Access Compliance Report

Public Rights-of-Way

(Curb Ramps)

Intersection ID: 28962	Main Street: HORNELL_PL	Cross Street: TROTWOOD_DR	Location: SW
ADA ID: D4AFEB18B78F	Ramp Type: Perp	Initial Pass/Fail: Fail	Overall Compliance: No
Severity Score: 10			
Codes/Mitigation Info/Possible Solution		Field Measurements/Component Compliance

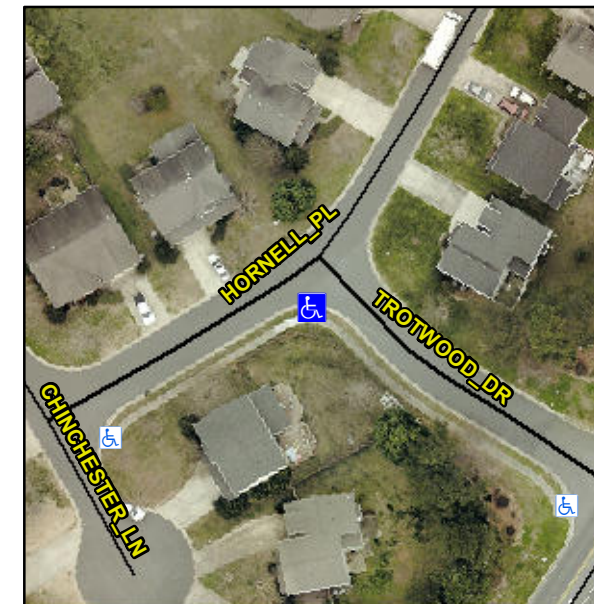
Not Found, R304.5.1, R304.5.3

Compliance	Description	Data	Compliance	Description	Data
N/A	Ramp Length (in)	45.5	Yes	Ramp Slope (%)	8.2
No	Ramp Width (in)	39.5	No	Ramp XSlope (%)	2.6
N/A	Flare Type LT	N/A	N/A	Flare Type RT	N/A
N/A	Flare Slope LT (%)	N/A	N/A	Flare Slope RT (%)	N/A
N/A	Flare Traversable LT?	N/A	N/A	Flare Traversable RT?	N/A
N/A	Landing Length (in)	N/A	N/A	DWS Provided?	N/A
N/A	Landing Width (in)	N/A	N/A	DWS Contrast?	N/A
N/A	Landing Slope (%)	N/A	N/A	DWS Length (in)	N/A
N/A	Landing X Slope (%)	N/A	N/A	DWS Full Width?	N/A
N/A	Landing Curb? (Y/N)	N/A	N/A	DWS Offset (in)	N/A
N/A	Shared Landing?	N/A			
N/A	Gutter Ponding?	N/A	N/A	Gutter Slope (%)	N/A
N/A	Gutter Lip Ht (in)	N/A	N/A	Gutter X Slope (%)	N/A
N/A	Painted X Walk1?	No	N/A	Painted X Walk2?	N/A
	X Walk 1 Direction	To E		X Walk 2 Direction	N/A
N/A	X Walk 1 Width (in)	N/A	N/A	X Walk 2 Width (in)	N/A
	X Walk 1 Slope (%)	3.5		X Walk 2 Slope (%)	N/A
	X Walk 1 X Slope (%)	0.6		X Walk 2 X Slope (%)	N/A

Remove & Replace Entire Ramp.
